Form C-103
 Revised August 1, 2011

WELL API NO. 30-025-25025 ✓
5. Indicate Type of Lease STATE <input type="checkbox"/> FEE <input checked="" type="checkbox"/>
6. State Oil & Gas Lease No.
7. Lease Name or Unit Agreement Name H T Mattern NCT C ✓
8. Well Number: 5 ✓
9. OGRID Number 4323 ✓
10. Pool name or Wildcat Blinberry, Drinkard, Wantz, Abo
11. Elevation (Show whether DR, RKB, RT, GR, etc.) 3491' GL

Well: **H. T. Mattern (NCT-C) # 5**

Current Wellbore Diagram

Proposed Wellbore Diagram

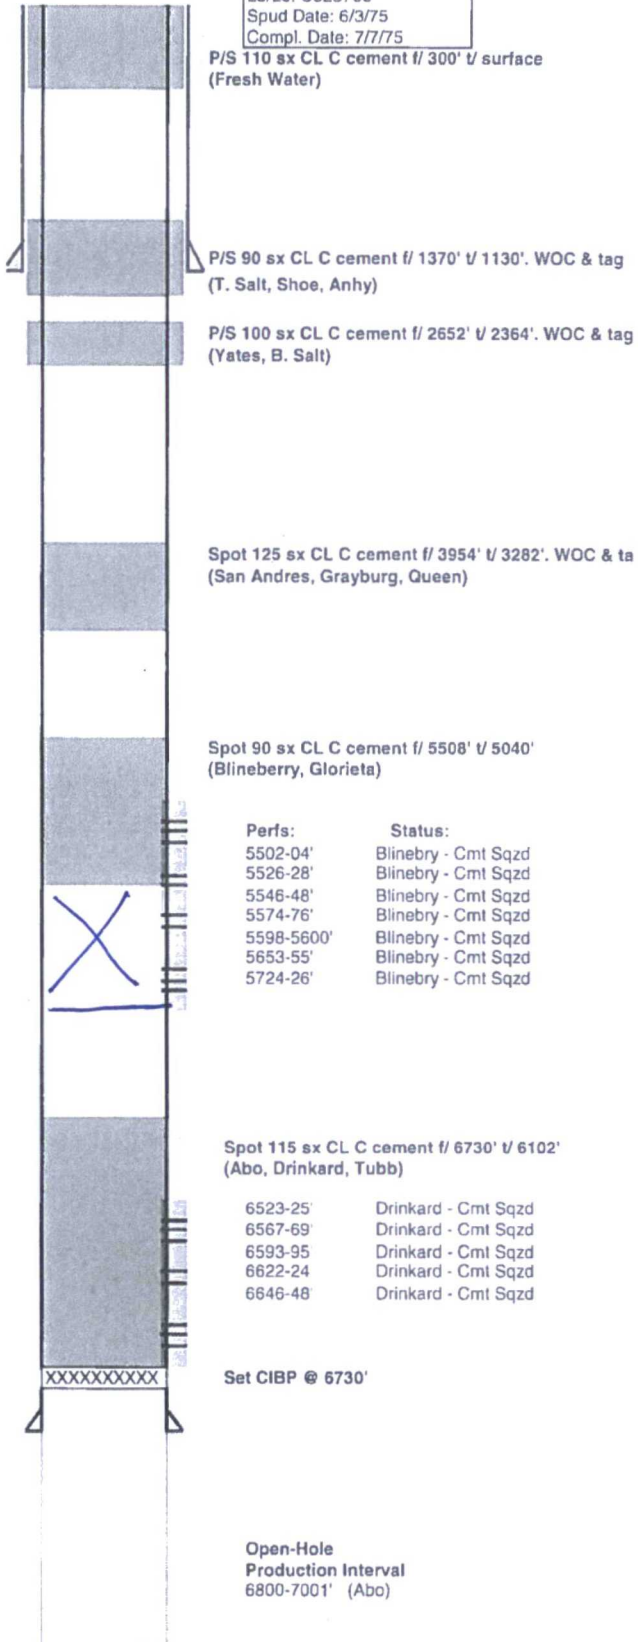
- Spot ~~90~~ **5774'** sx CL C cement plug f/ ~~5508'~~ t/ 5040' (Blinberry, Glorieta). If successful pressure test was not obtained in step 2 or 3, WOC & tag.
